**Daniel J. MacDonald Modernization**

.1 The following Drawings are revised and re-issued with this addendum. Revisions are shown in bubbled areas on drawings. The following descriptions of revisions are for convenience only and do not define or limit the extent of actual revisions indicated on drawings:

End of NORR Addendum No. 7

drawing no. M60-01 no. du dessin

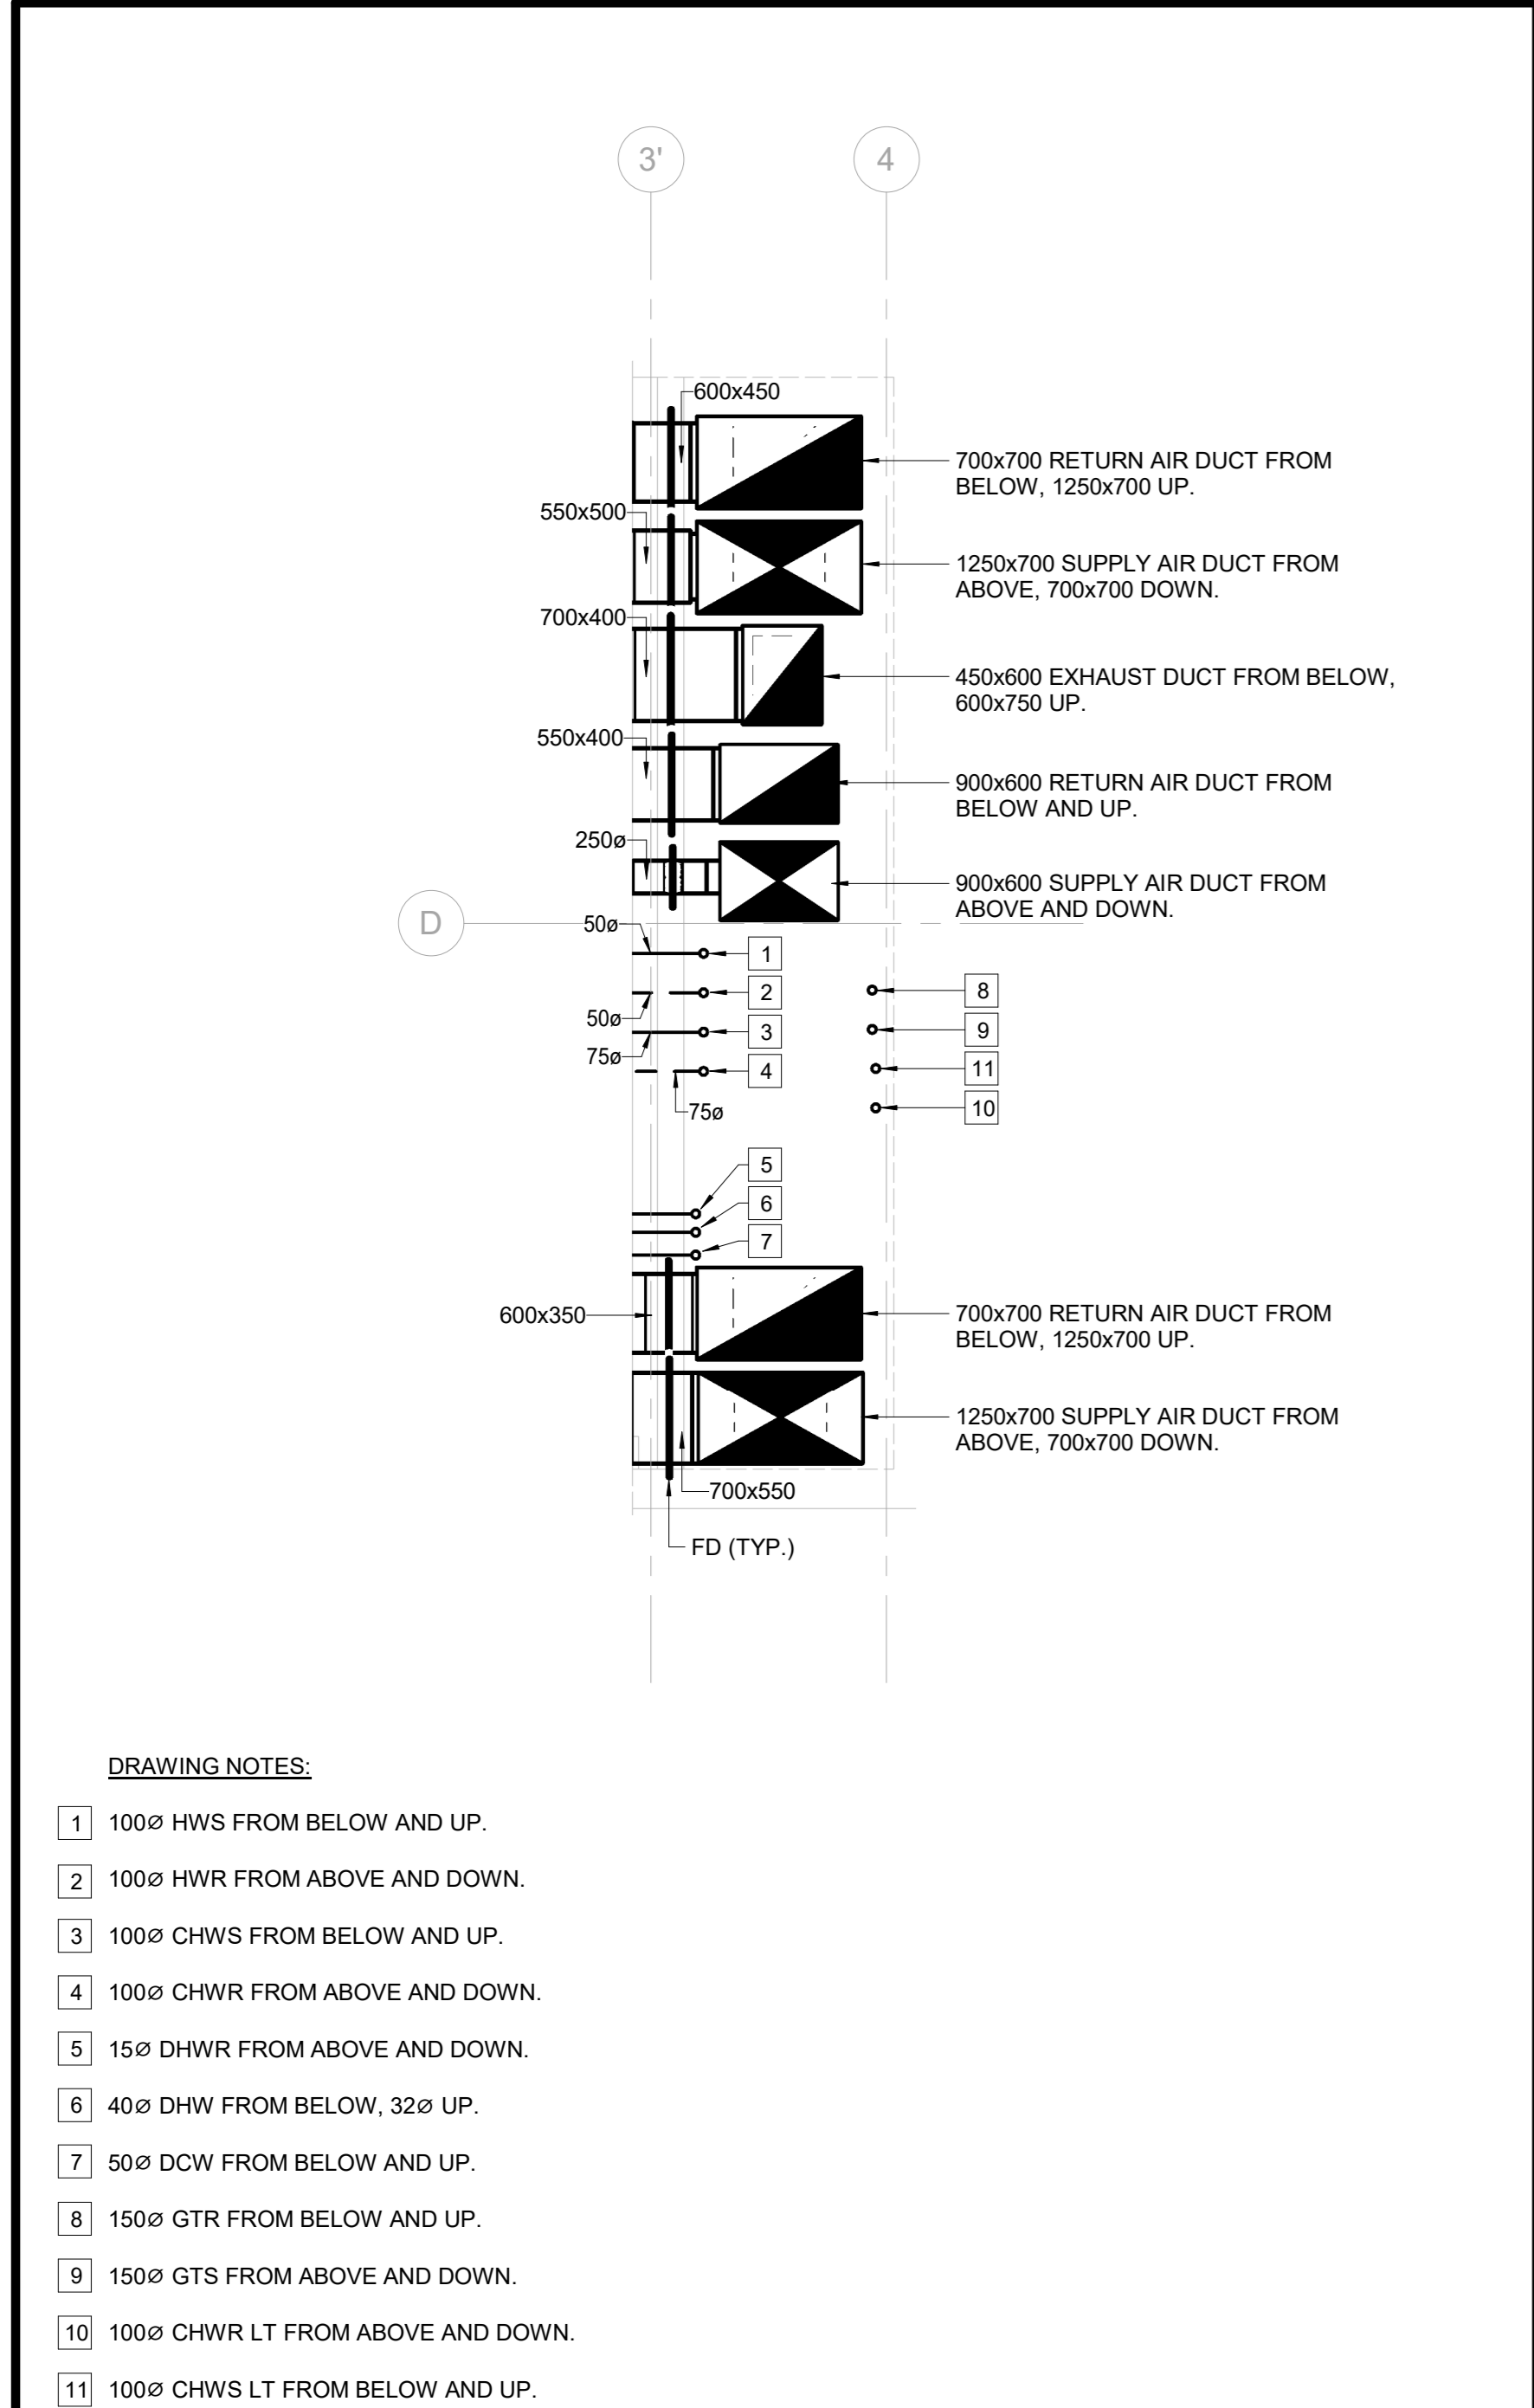
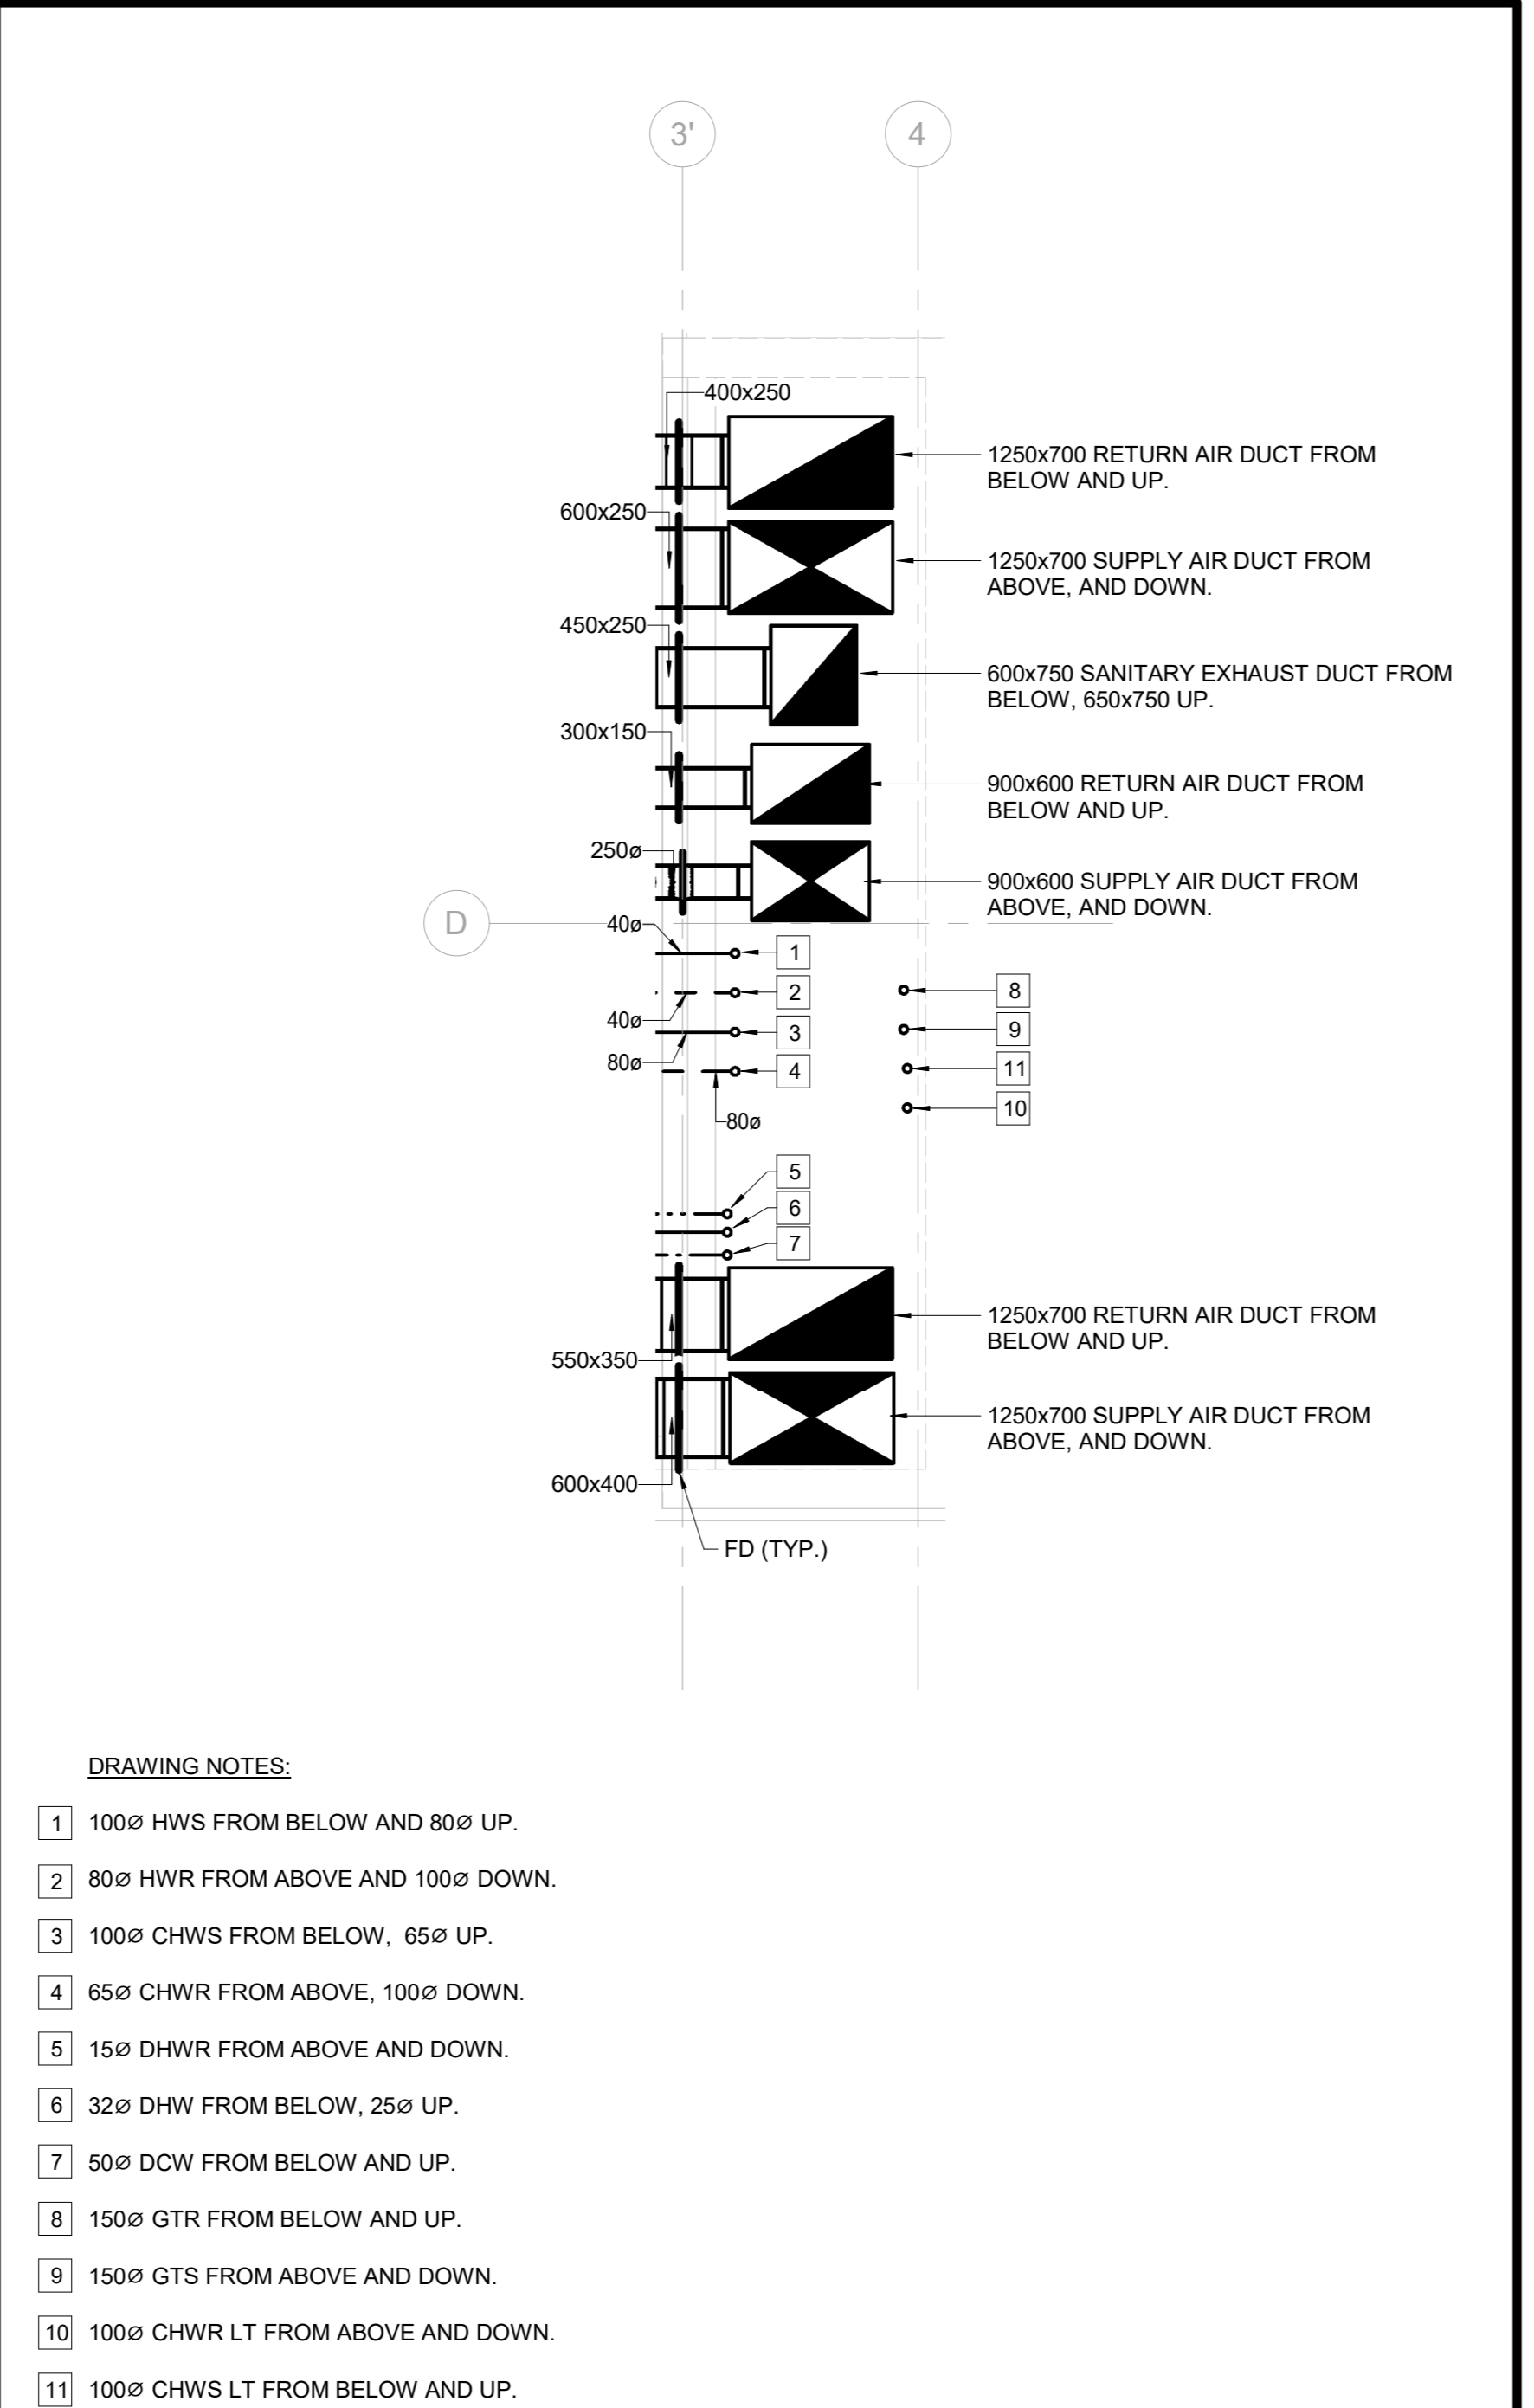
- .8 Drawing M53-06 - HYDRONIC - PENTHOUSE FLOOR NEW WORK
  - .1 Revised pipe sizes.
- .9 Drawing M60-01 - MECHANICAL RISER DETAILS PART PLANS
  - .1 Revised notes reflecting pipe sizes.
